UNITED STATES PATENT AND TRADEMARK OFFICE

APPLICATION NO.	FILING DATE	FIRST NAMED INVENTOR	ATTORNEY DOCKET NO.	CONFIRMATION NO.
10/698,269	10/31/2003	William Gerald Wyatt	004578.1384	1666

Office Action Summary

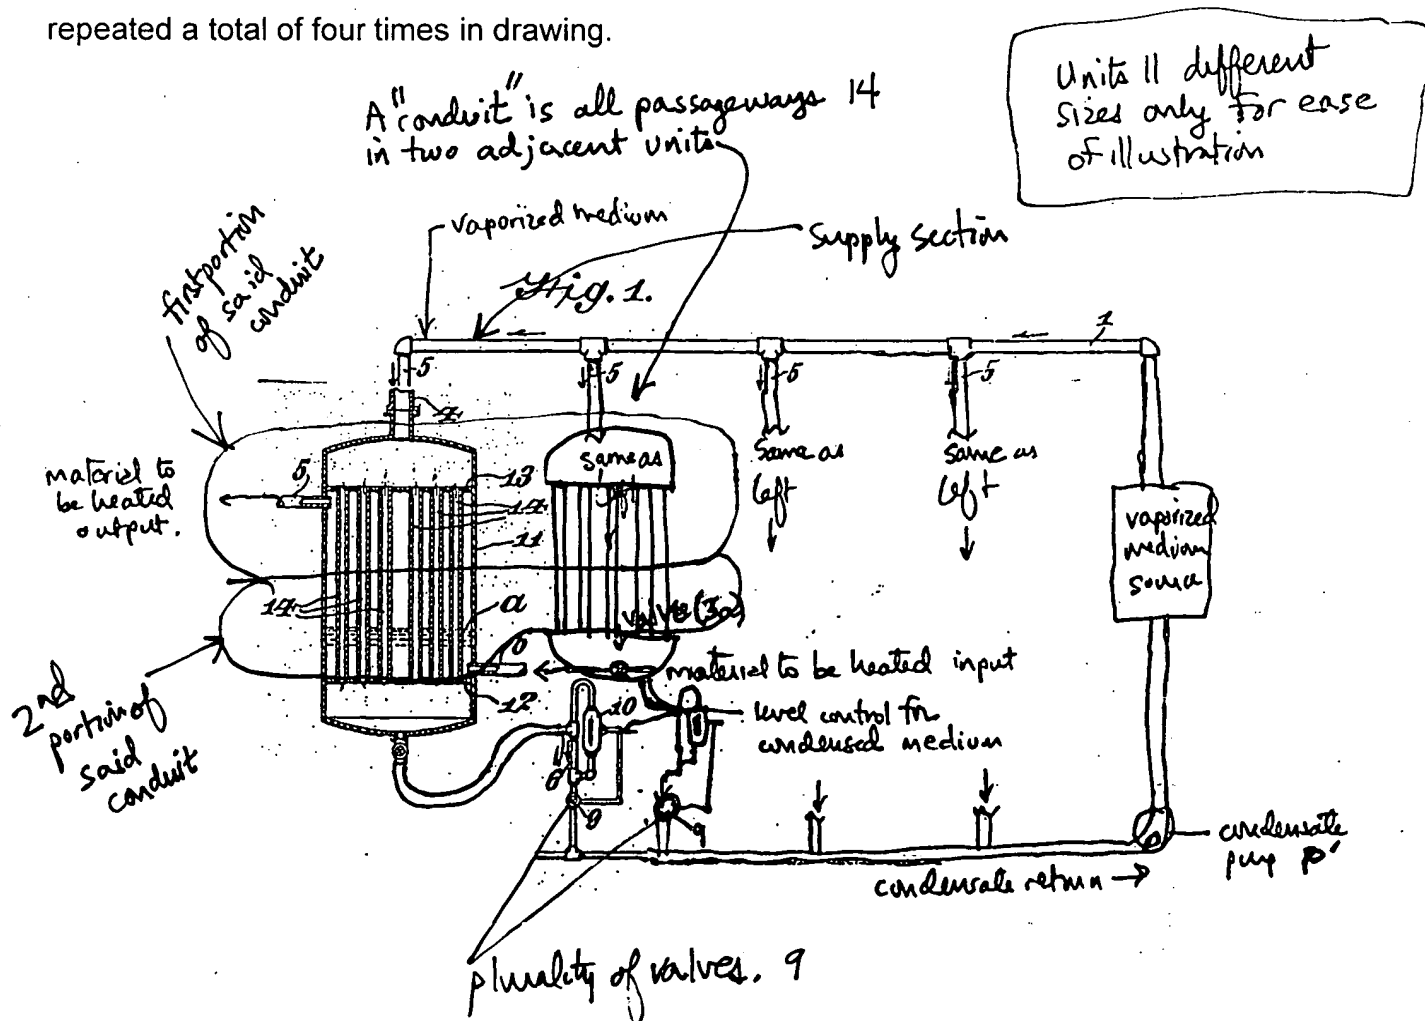
Applicant's response and amendments to the claims of August 3, 2006 have been studied carefully. In an extremely brief response, it is apparently applicant's contention that all of the passageways 14 in any two adjacent units (e.g. C and D) of Roulton cannot constitute "a conduit". The examiner does not understand why. In the elected species, applicant's own disclosure shows a plurality of passageways extending from a common coolant supply manifold 41 (one, 92, going to the right and curving downwardly and another one, 91, going off to the left and curving downwardly). These two separate sections are referred to as a "conduit". Thus, it is apparent that applicant's "conduit" can contain multiple branches connected to a common manifold 41, very similar to what is shown in any two adjacent units in Roulton or Larionoff '180.
